Access Compliance Report

Public Rights-of-Way

Intersection ID: 29117	Main Street: HAZY_VALLEY_CT	Cross Street: HIGHLAND_PARK_DR	Location: E
ADA ID: 8B33F24397AD	Ramp Type: PerpDiag	Initial Pass/Fail: Fail	Overall Compliance: No
Severity Score: 10			
Codes/Mitigation Info/Possible Solution		Field Measurements/Component Compliance

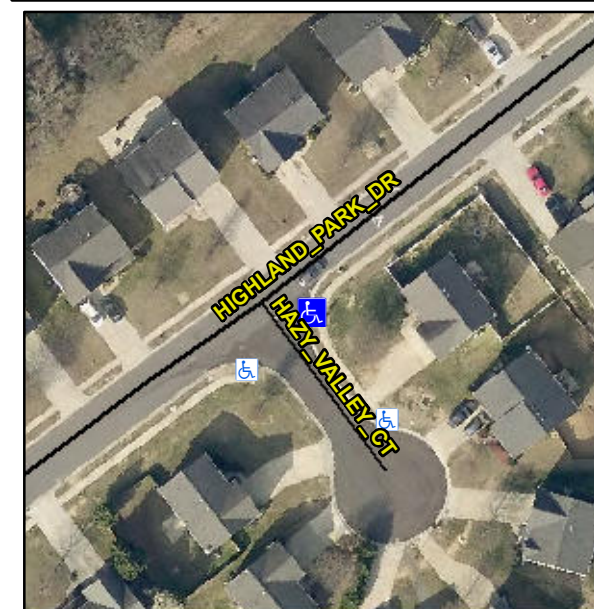
Remove & Replace Curb Ramp With Two New Directional Ramps or Equivalent.

R304.5.1, R304.5.3

Compliance	Description	Data	Compliance	Description	Data
N/A	Ramp Length (in)	48.0	Yes	Ramp Slope (%)	6.9
No	Ramp Width (in)	46.0	No	Ramp XSlope (%)	2.3
N/A	Flare Type LT	N/A	N/A	Flare Type RT	N/A
N/A	Flare Slope LT (%)	N/A	N/A	Flare Slope RT (%)	N/A
N/A	Flare Traversable LT?	N/A	N/A	Flare Traversable RT?	N/A
N/A	Landing Length (in)	N/A	N/A	DWS Provided?	N/A
N/A	Landing Width (in)	N/A	N/A	DWS Contrast?	N/A
N/A	Landing Slope (%)	N/A	N/A	DWS Length (in)	N/A
N/A	Landing X Slope (%)	N/A	N/A	DWS Full Width?	N/A
N/A	Landing Curb? (Y/N)	N/A	N/A	DWS Offset (in)	N/A
N/A	Shared Landing?	N/A			
N/A	Gutter Ponding?	N/A	N/A	Gutter Slope (%)	N/A
N/A	Gutter Lip Ht (in)	N/A	N/A	Gutter X Slope (%)	N/A
N/A	Painted X Walk1?	No	N/A	Painted X Walk2?	No
	X Walk 1 Direction	To NW		X Walk 2 Direction	To SW
N/A	X Walk 1 Width (in)	N/A	N/A	X Walk 2 Width (in)	N/A
	X Walk 1 Slope (%)	9.3		X Walk 2 Slope (%)	6.3
	X Walk 1 X Slope (%)	6.5		X Walk 2 X Slope (%)	6.9
